# FINAL DRAFT MINUTES

## October 21, 2021 Standards Committee Meeting

RE: Minutes from the October 21, 2021 Standards Committee Meeting

PROBLEM(S) ENCOUNTERED: The Standard Drawing series for flagger operations (E 801-TCFO) largely date back to 1997 and include details for work that does not include flagging. INDOT Standard Drawings E 801-TCFO-03, E 801-TCTC-09, and E 801-TCTC-10 depict mobile operations and should be combined into a new series just for mobile operations. Other sheets in the temporary closure series (801-TCTC) are duplicates of other drawings or show information that should be detailed in the plans.

E 801-TCTC-10 MAINTENANCE OF TRAFFIC FOR RPM REFLECTOR REPLACEMENT (WITH MARKUPS)

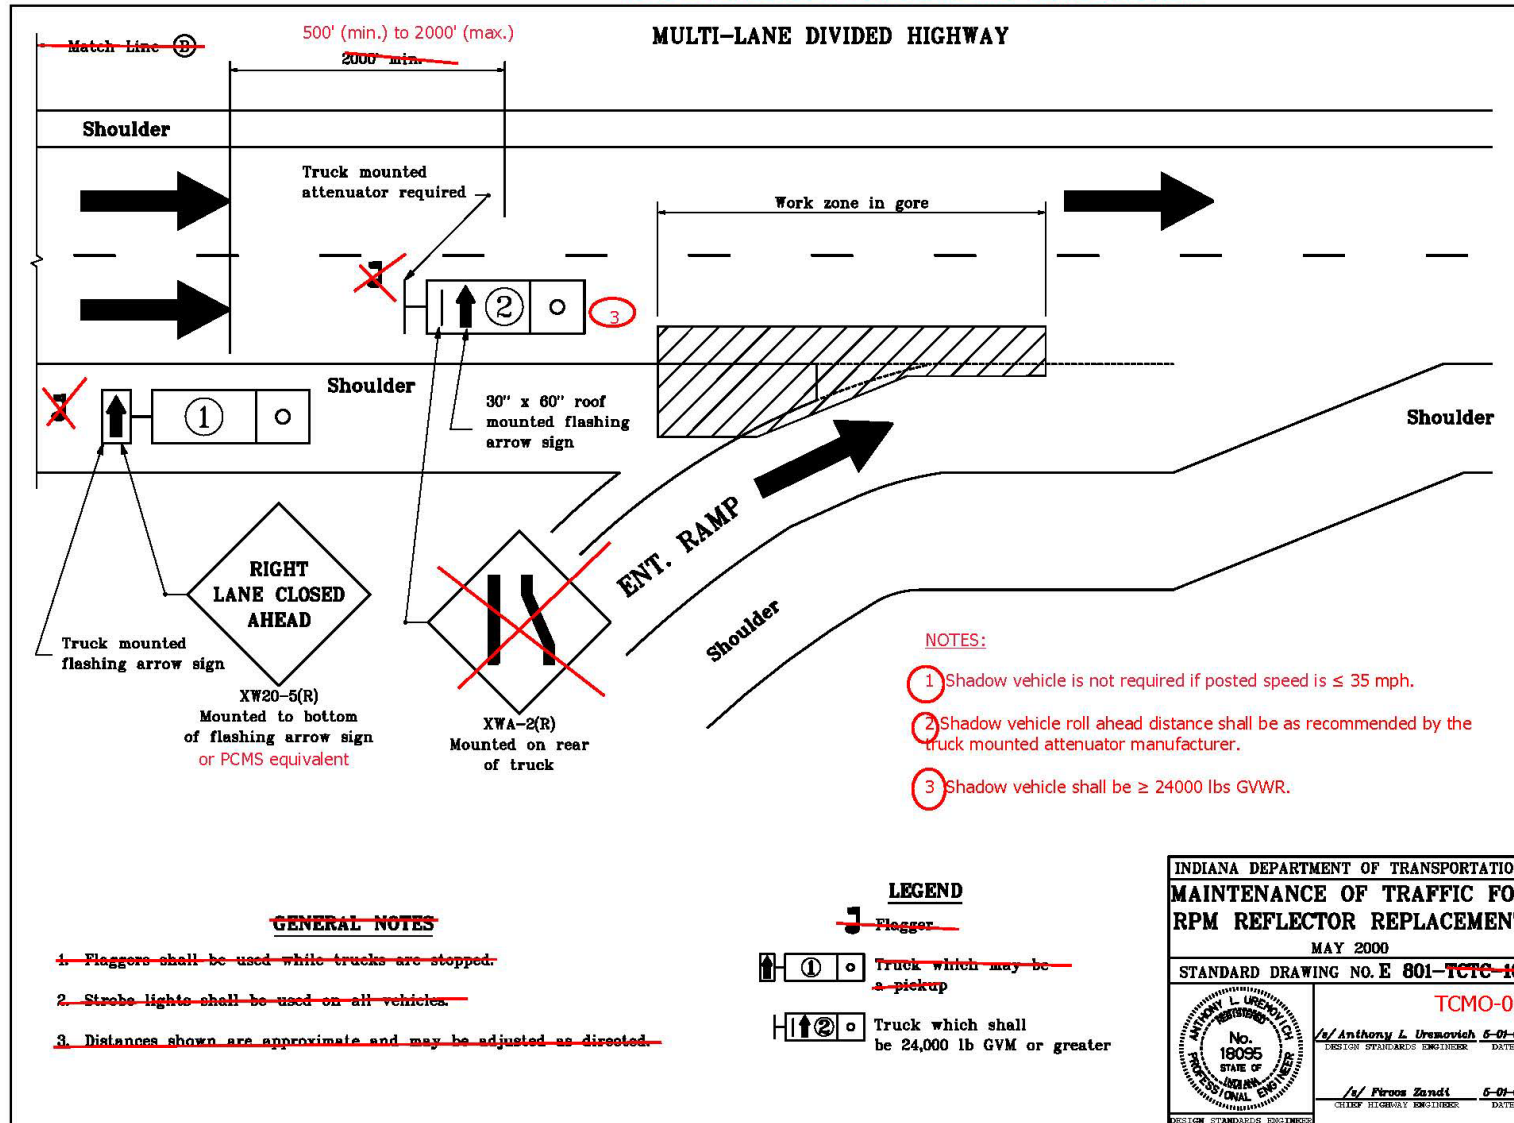
Move to new series on Traffic Control for Mobile Operations

E 801-TCFO-02 FLAGGER OPERATION FOR MULTIPLE WORK AREAS WITH POSTED SPEED  $\geq$  50 MPH (PROPOSED DRAFT)

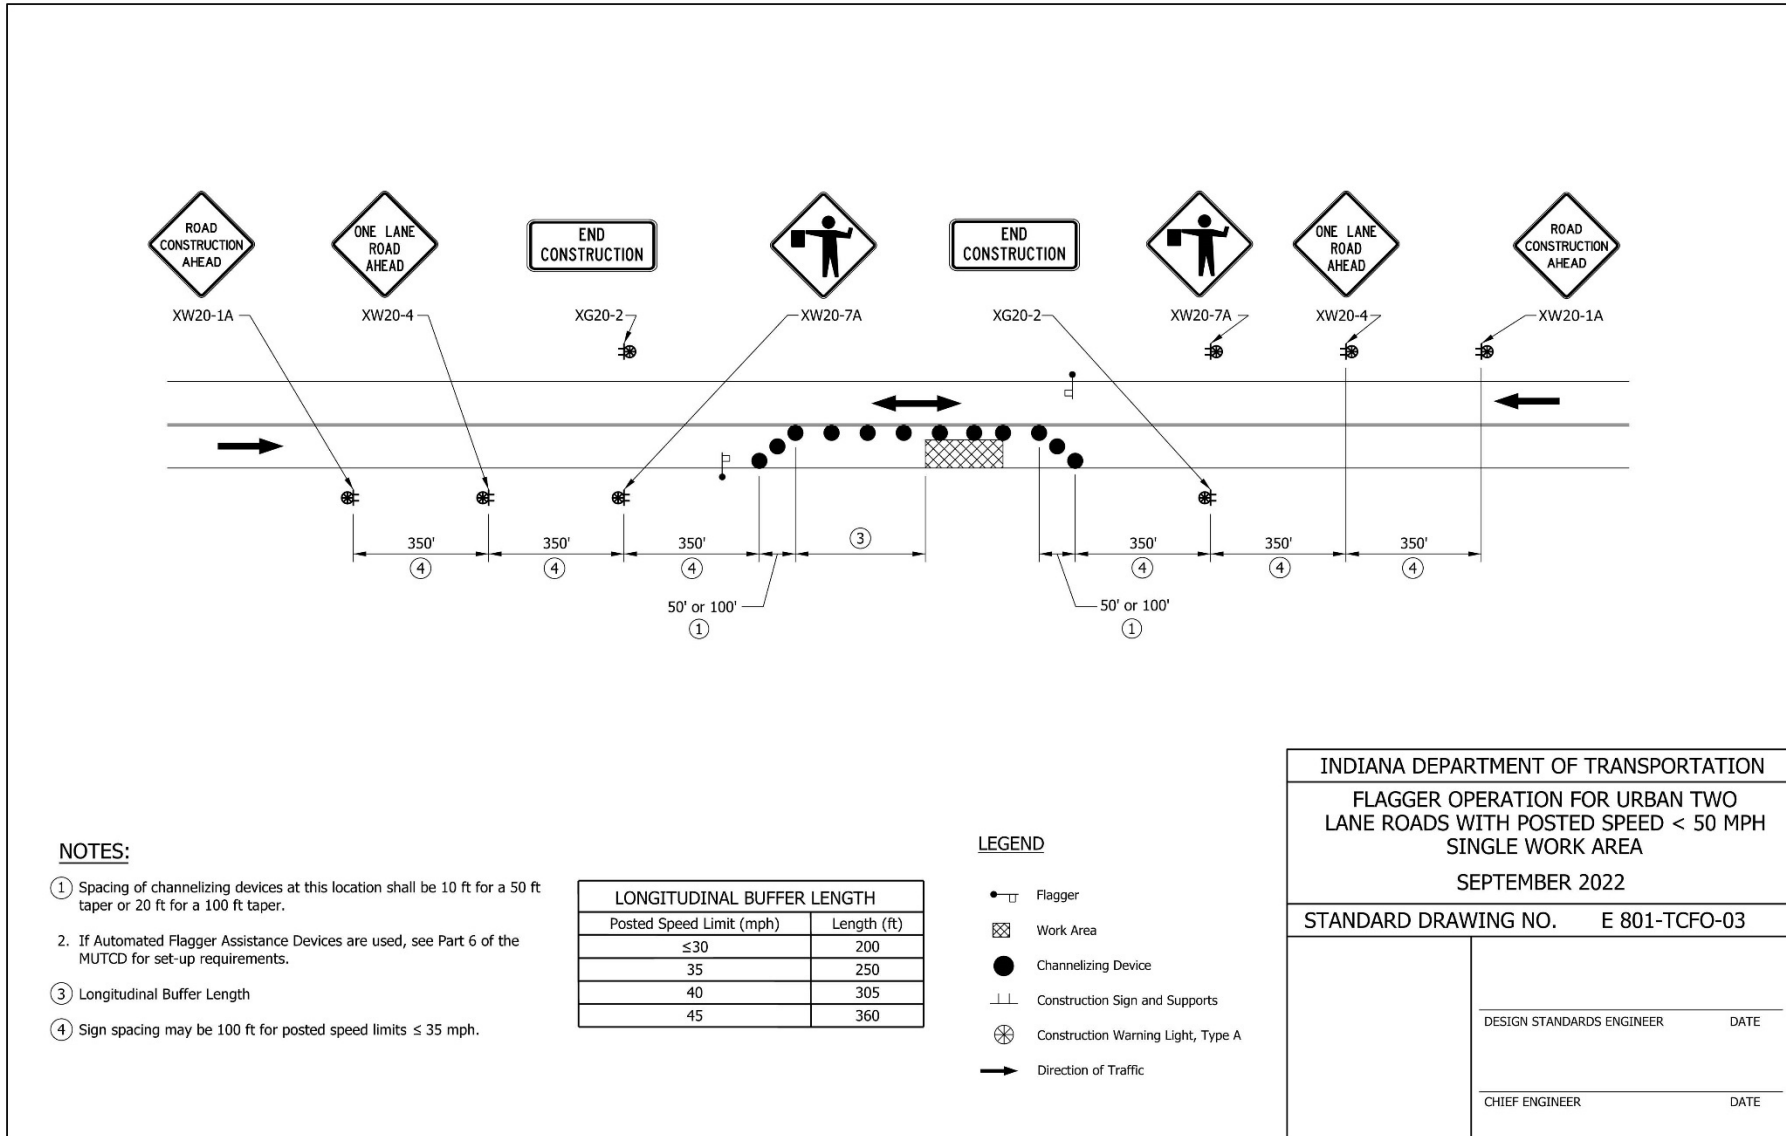
Mr. Koch asked if the taper rate shown in 801-TCFO-02, 3 & 4 is optional, and if further guidance is needed. Mr. Bruno responded that there is existing guidance on this as Figure 503-7D of the Design Manual recommends 100 ft as the two-way traffic taper. However, the two-traffic taper in IMUTCD Figure 6H-10 on flagging is 50 to 100 ft, which matches the current 801-TCFO series. As a result, an option for 50 ft two-way traffic tapers is being retained for situations such as where the shorter taper would keep a driveway out of the work zone or would allow the flaggers to be able to see each other. The potential circumstances where a 50 ft taper may be used could be added as a note to IDM Figure 503-7D.
